MEMORANDUM

DATE: February 26, 1993

SUBJECT: **Technical Re-evaluation of Off-site Contaminant Plume Delineation at Sparton Technology, Inc., Albuquerque**

FIGURE 2: SOIL-GAS SURVEY - TCE

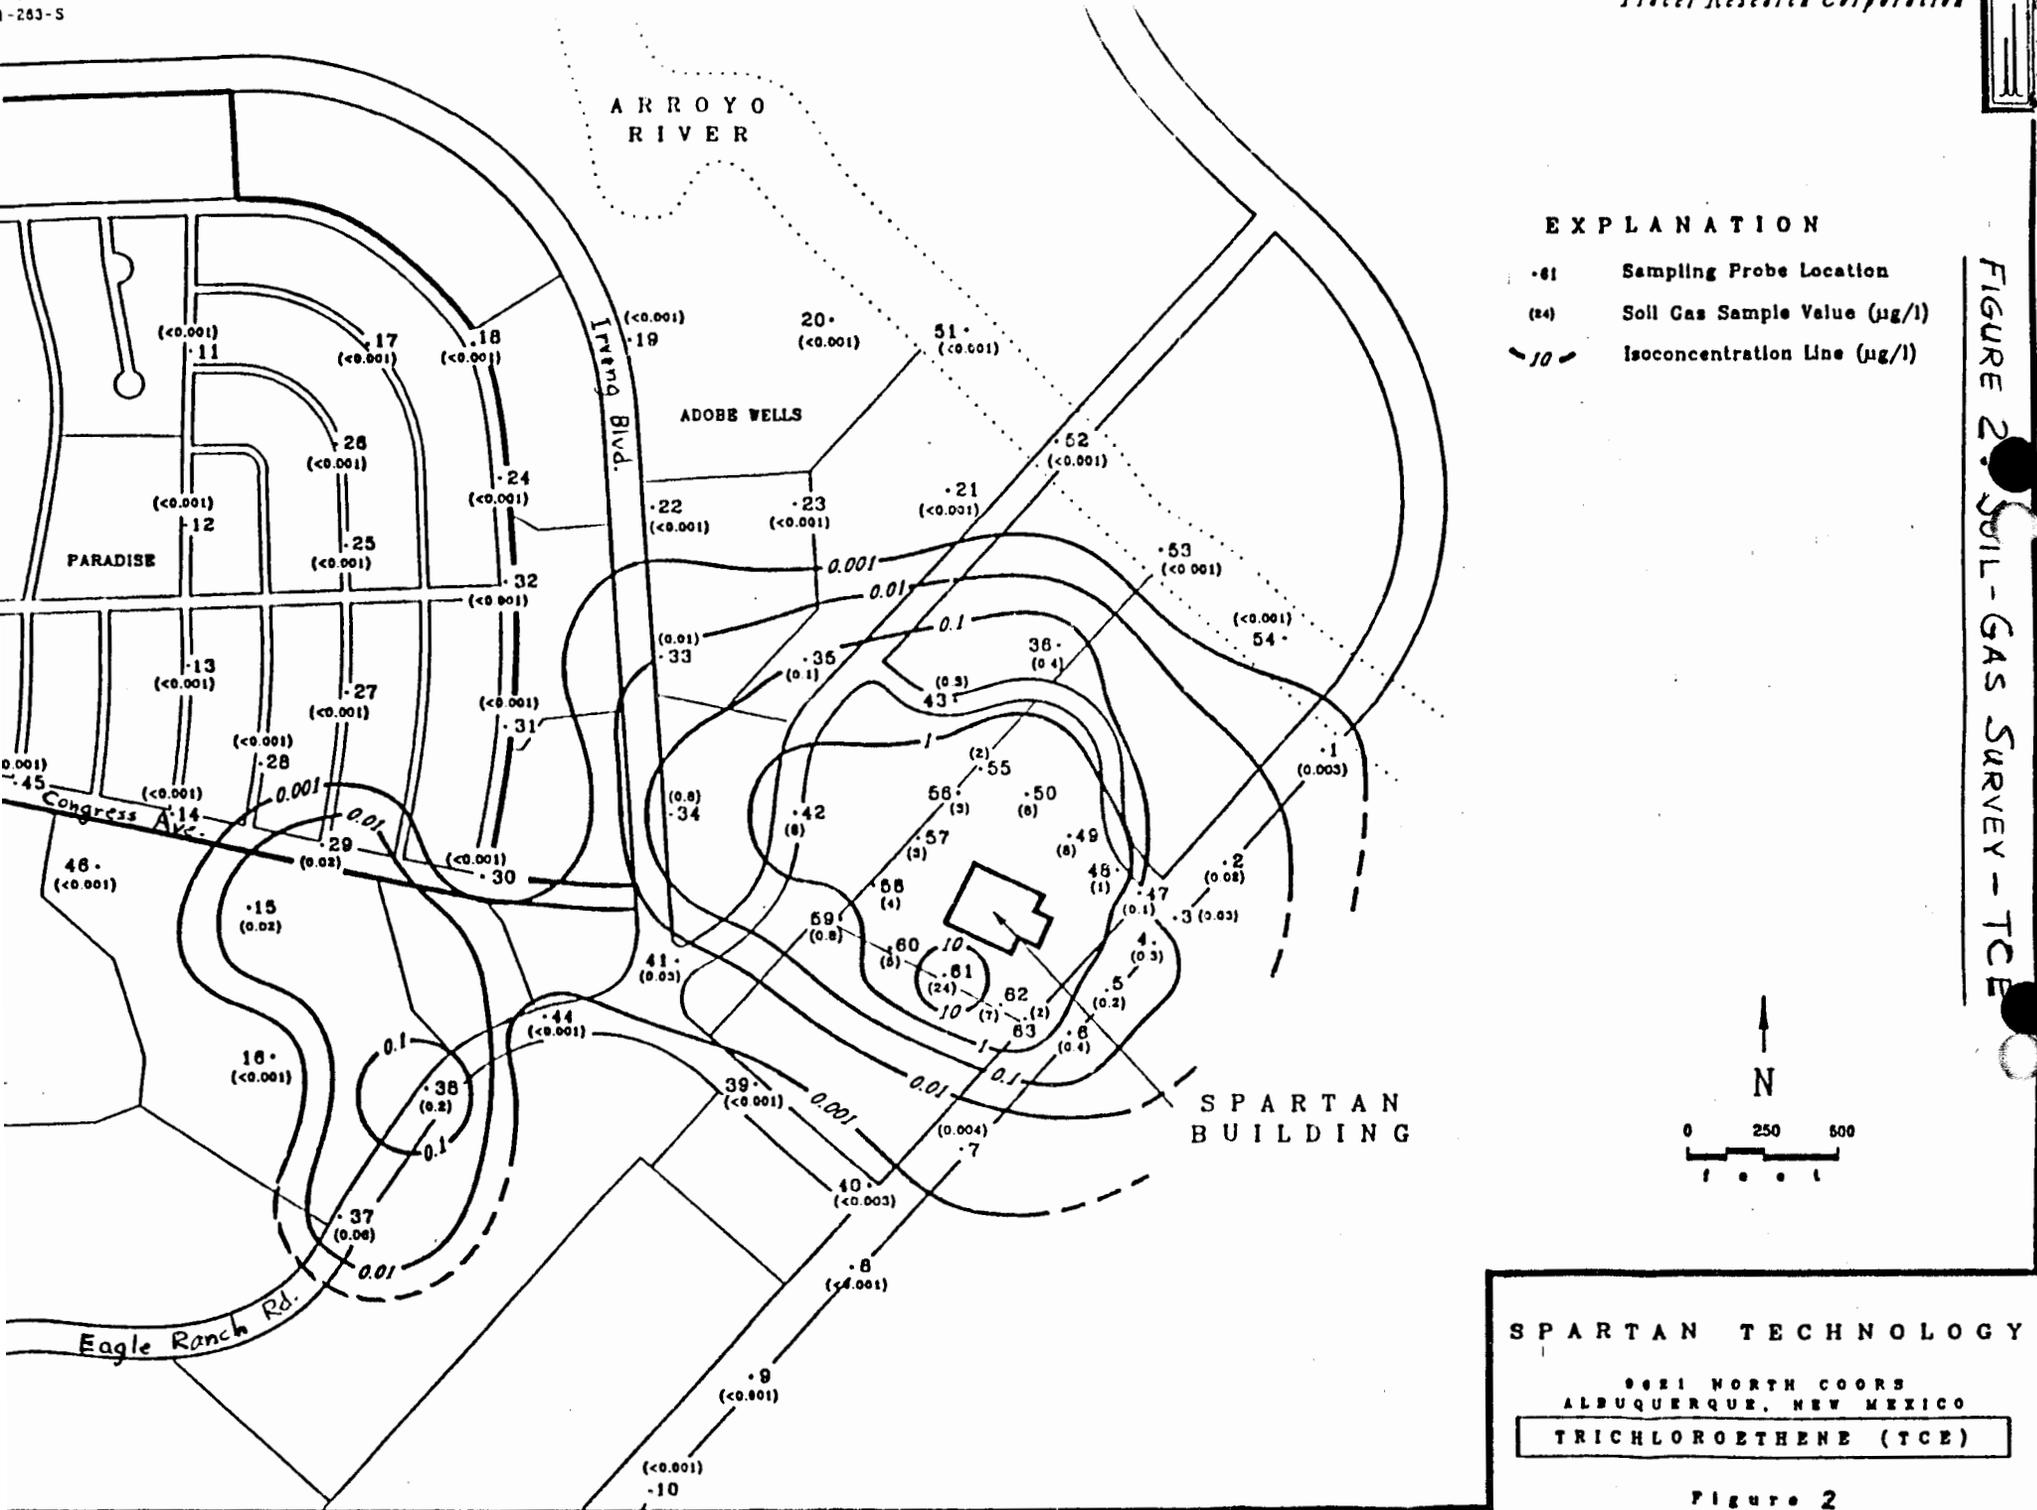
During ST's most recent soil-gas survey (June, 1990), anomalous values of TCE were encountered immediately south of Congress Avenue and west of Irving Boulevard (Fig. 2). These data suggest that there may be groundwater contamination in the UFZ below this general area. ST has not addressed this anomalous zone with any MW.

(1000) feet through which the plume may have progressed. Such a possibility is consistent with the soil-gas survey discussed above.

The intent of the AOC, CAP, and regulations discussed above is to ensure that the facility (ST) performs tasks deemed necessary to protect human health and the environment. If the contaminant plume has not been properly defined because of inadequate MW spacing, then the intent of the regulatory process has not been fulfilled. Additional MW's are therefore required to ensure that the contaminant plume has been properly delineated.
